Greater Columbus Convention Center North Facility

Chiller Replacement (Bid Package 2023-5)

Addendum 01

11/3/2023

SKS-01

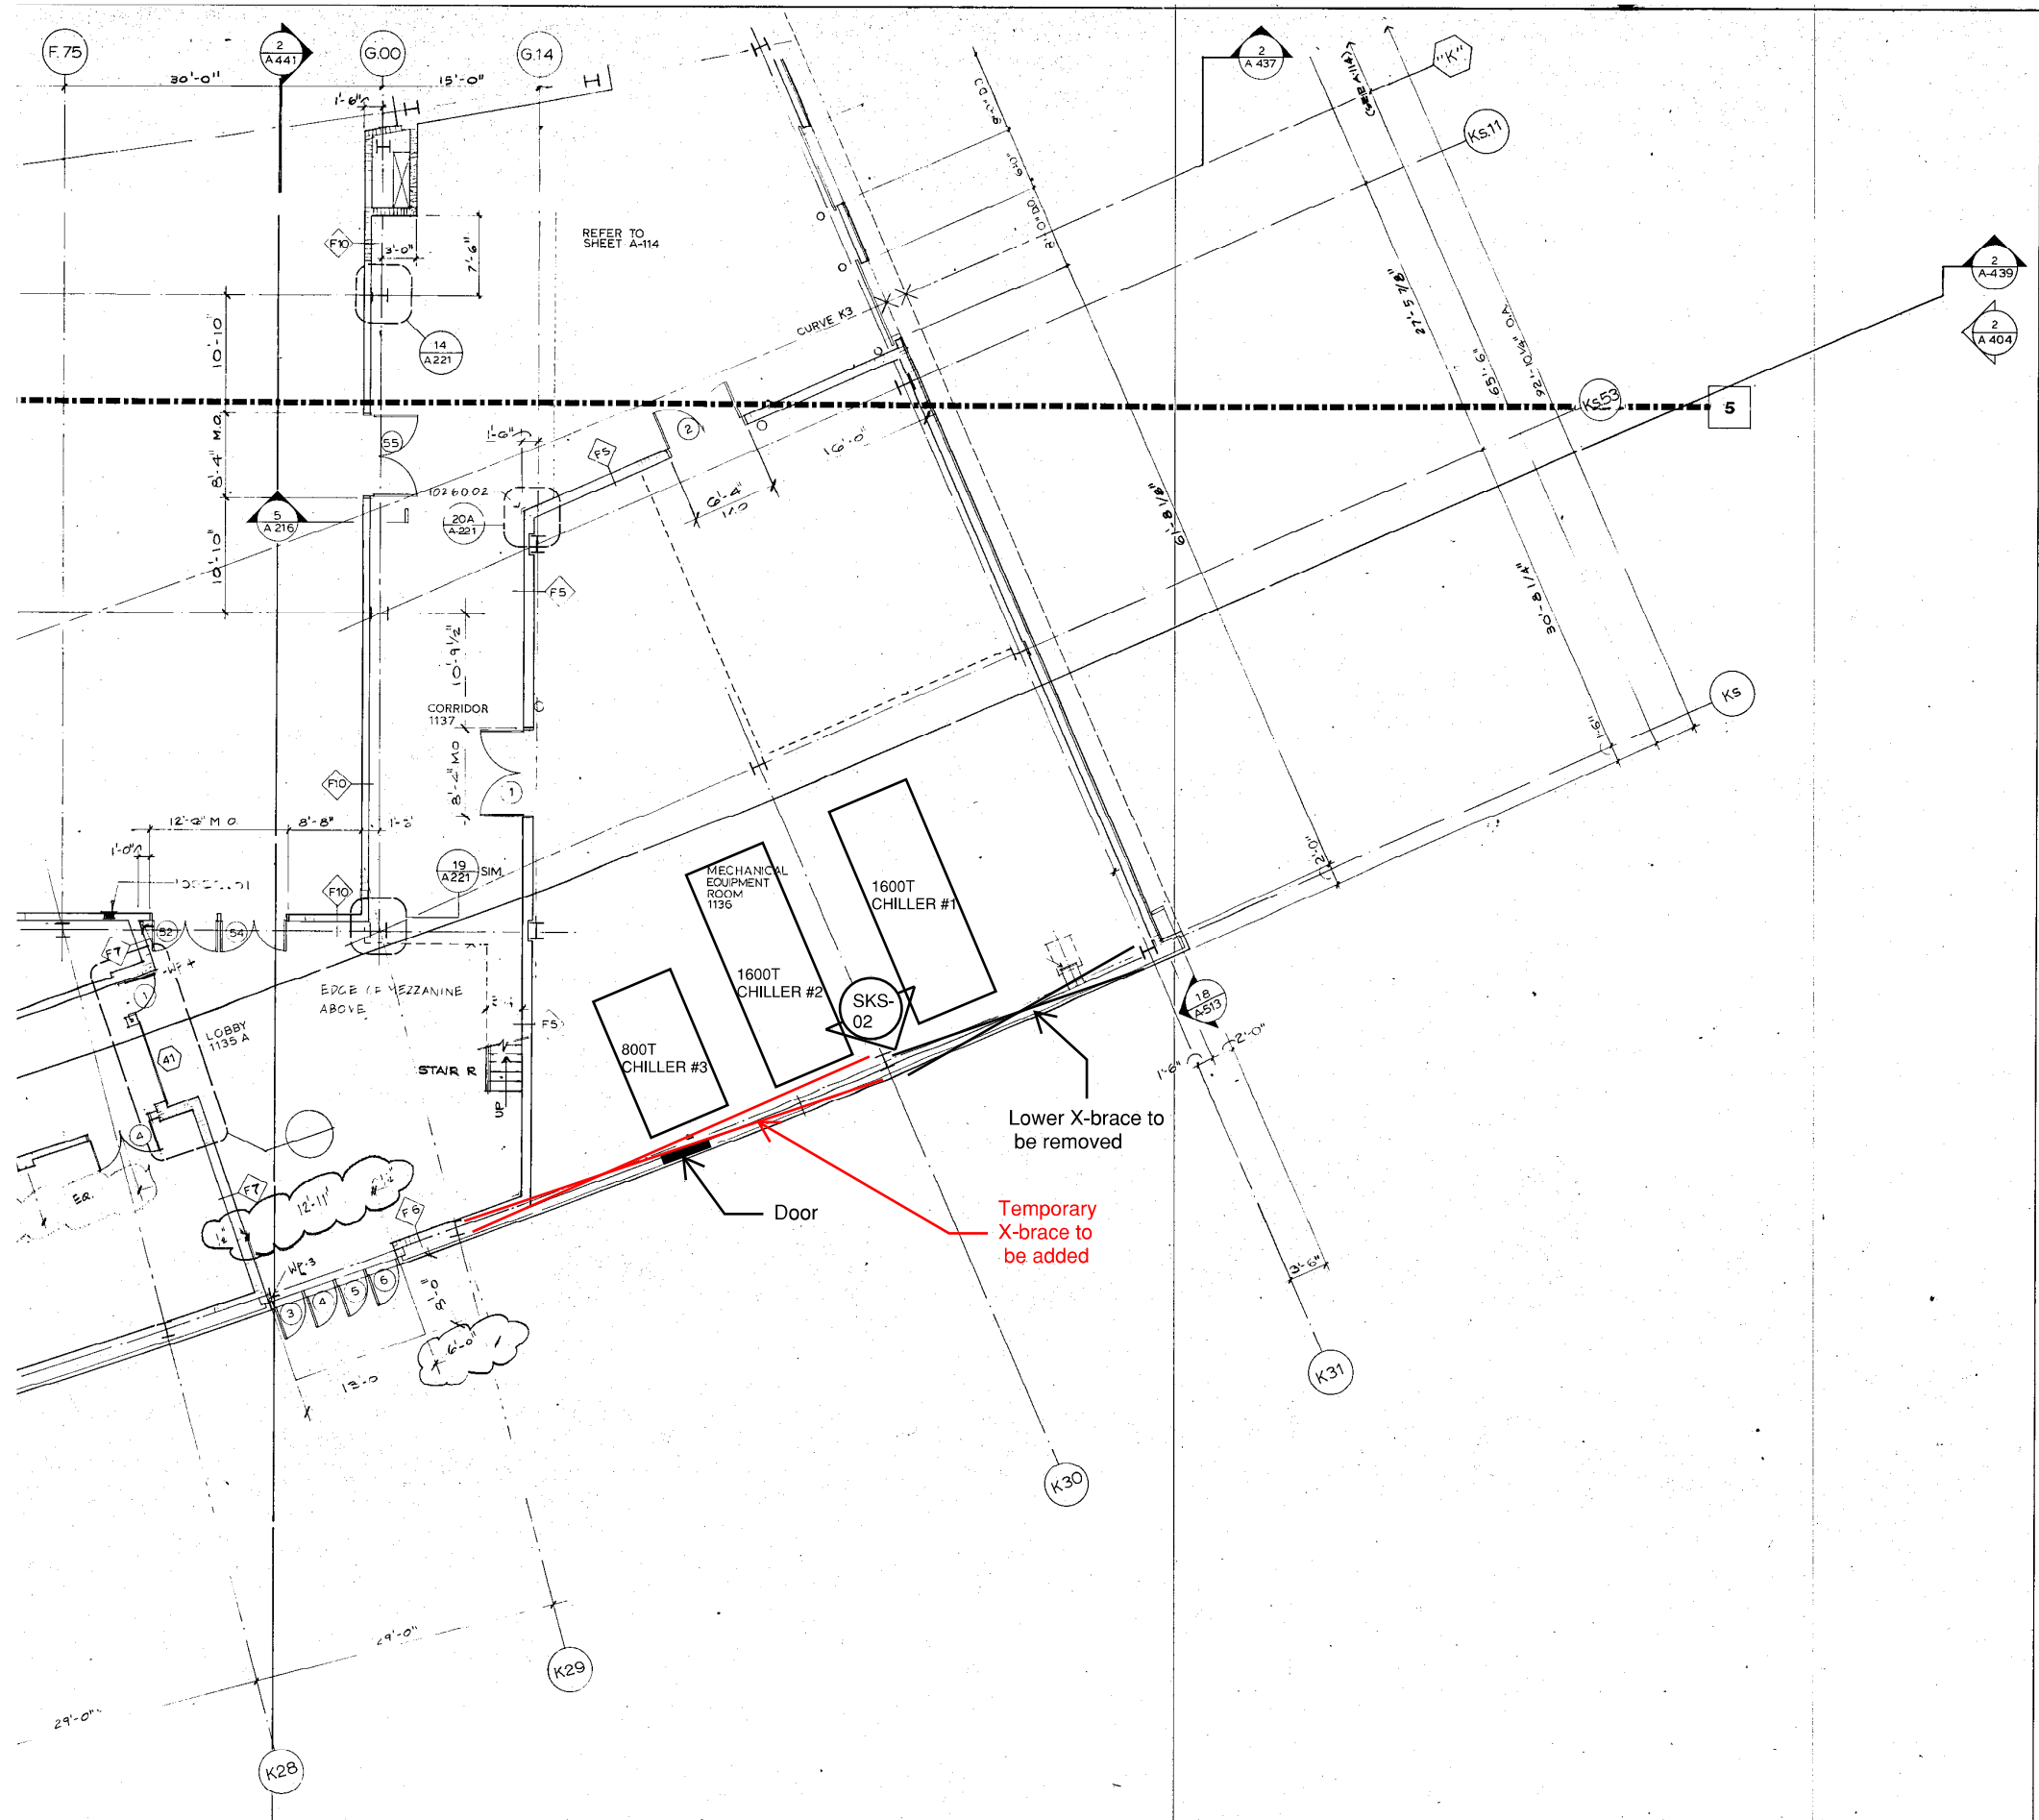
- a. SKS-01/SKS-02 to be issued in Addendum 01. Structural drawings to be incorporated into final Permit/Construction documents.
- 4) Site Walkthrough
- 5) General Questions

- a. Yes, one (1) 12'x12' opening for CH-1 replacement and, after that temporary opening has been closed, a separate 12'x12' opening for CH-2 and CH-3 replacement.

SKS-02

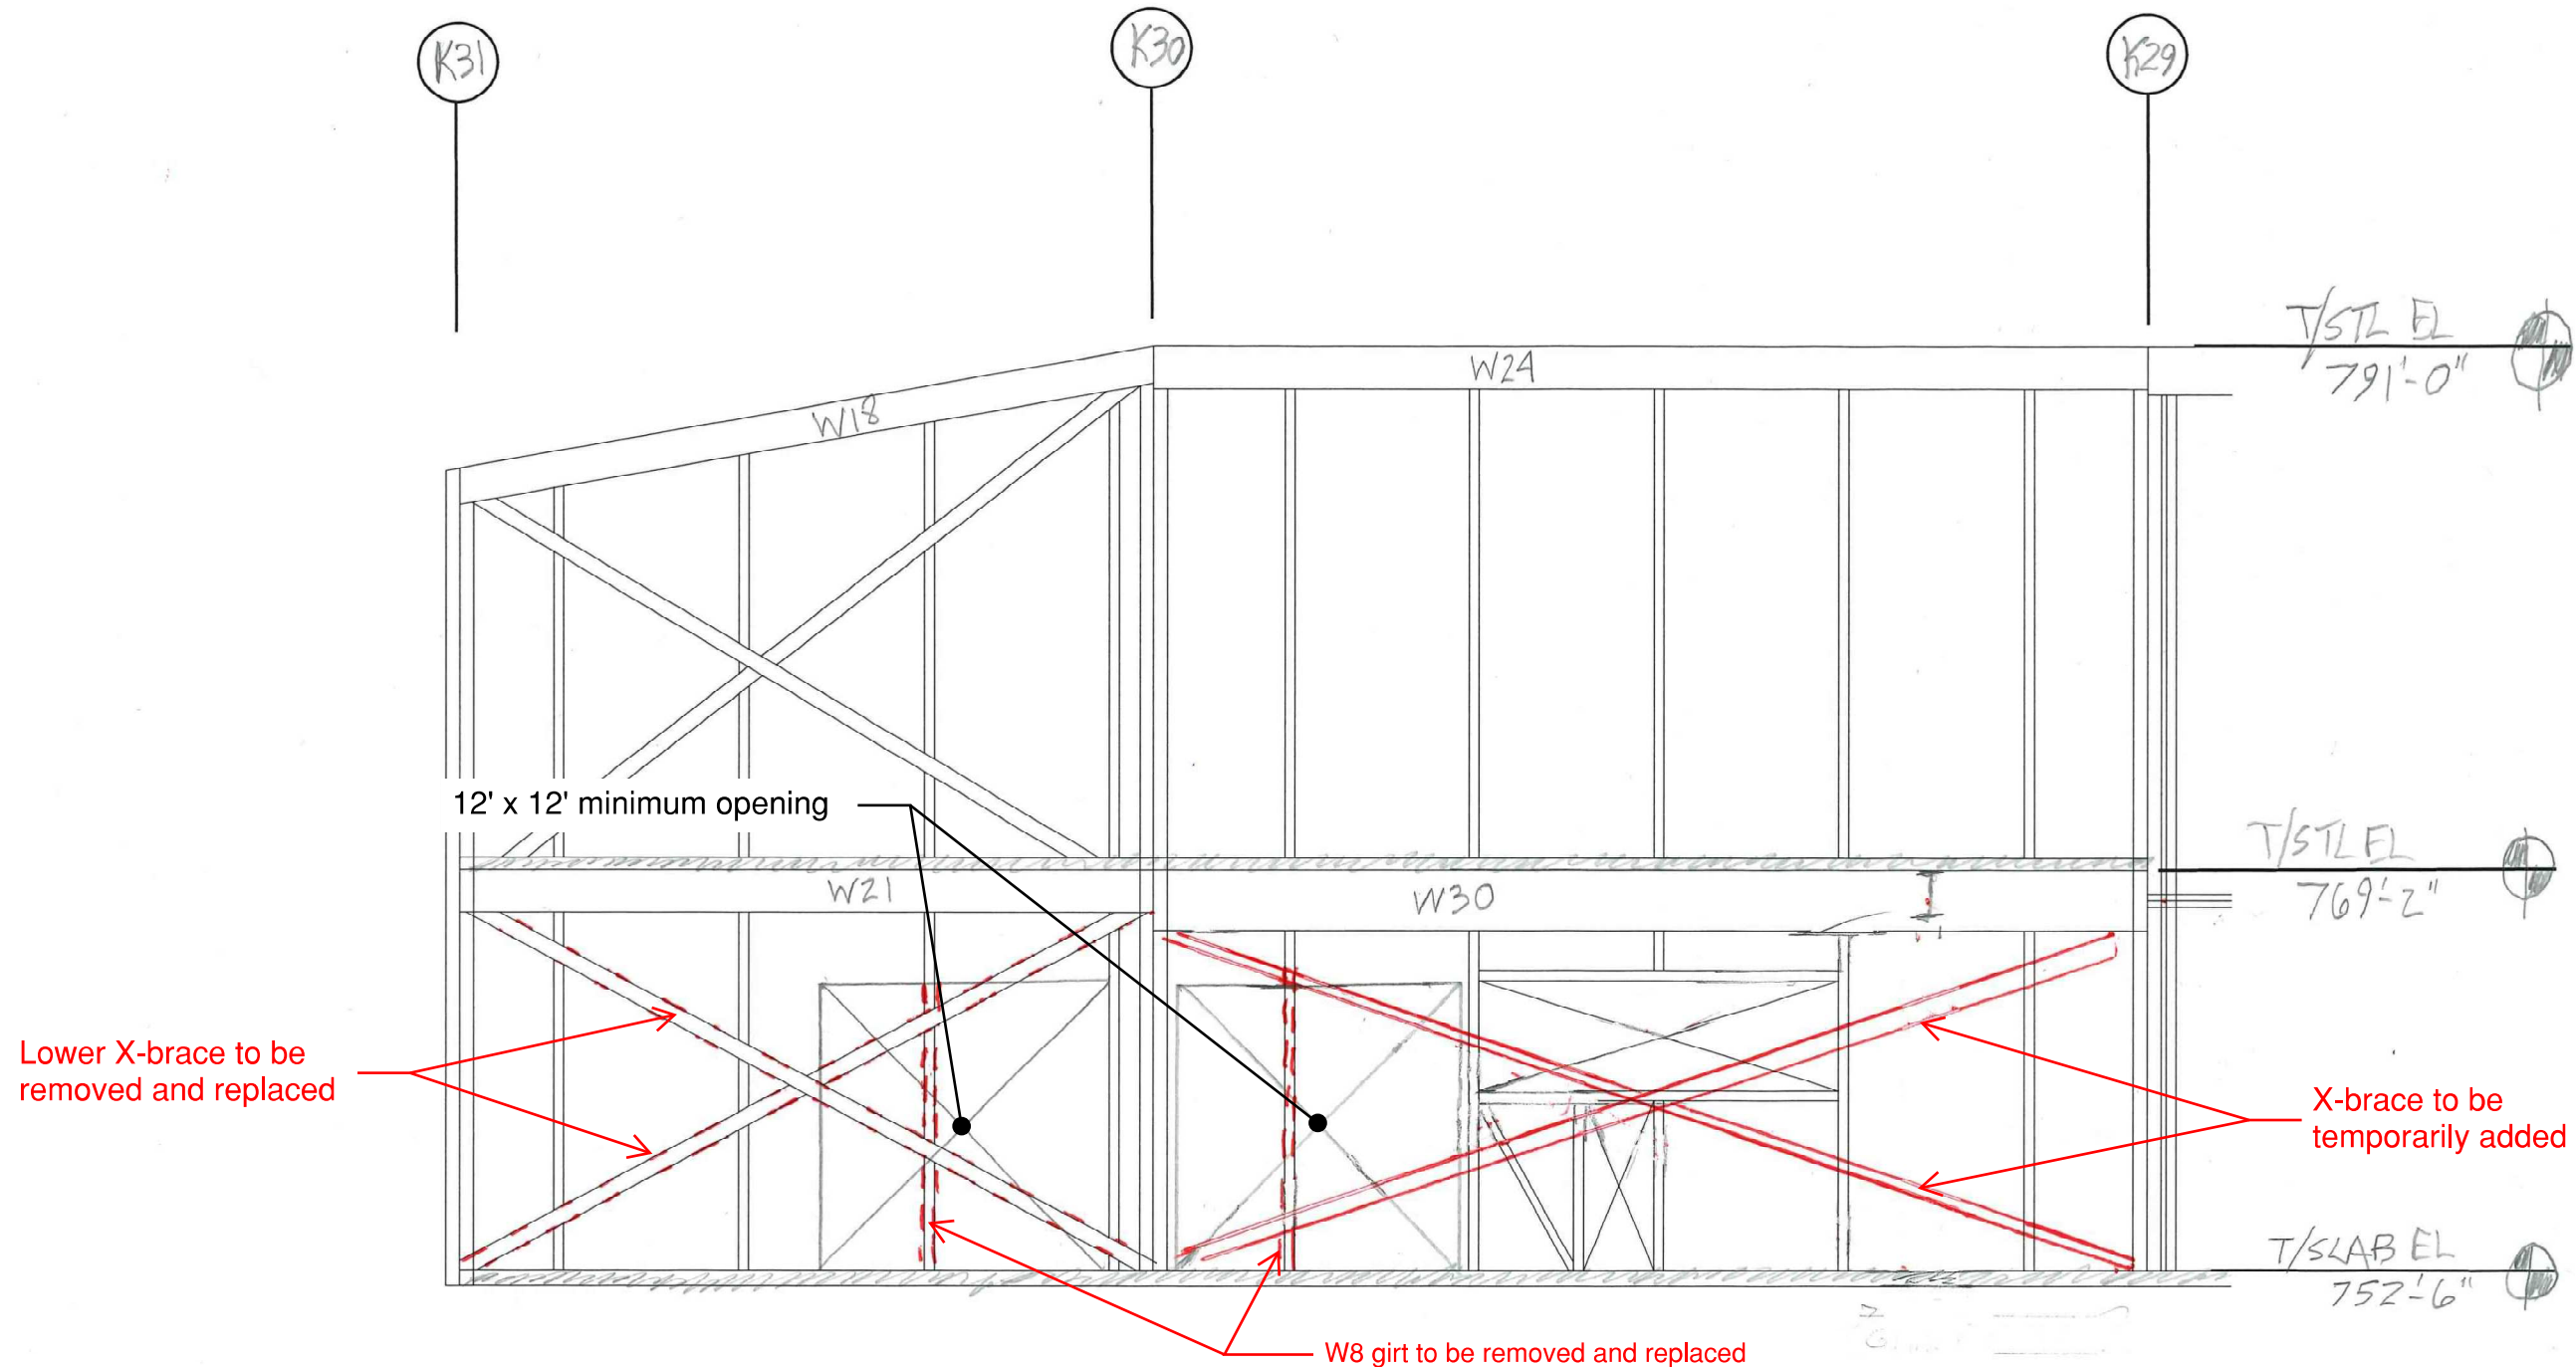
MODIFICATION TO EXTERIOR WALL FRAMING ALONG LINE Ks

PROPOSED SEQUENCE OF DEMOLITION/CONSTRUCTION AND CHILLER INSTALL:

1. Install X-brace between lines K29 and K30 (may be necessary to remove damper temporarily).
2. Remove lower X-brace and vertical W8 girt between lines K30 and K31.
3. Demo and install new Chiller #1 through opening in metal panel. Reinstall lower X-brace, vertical W8 girt, and metal panel between lines K30 and K31.
4. Remove X-brace, and W8 vertical girt between lines K29 and K30.
5. Demo and install new Chiller #2 and #3 through opening in metal panel. Reinstall vertical W8 girt, metal panel, and damper between lines K29 and K30.
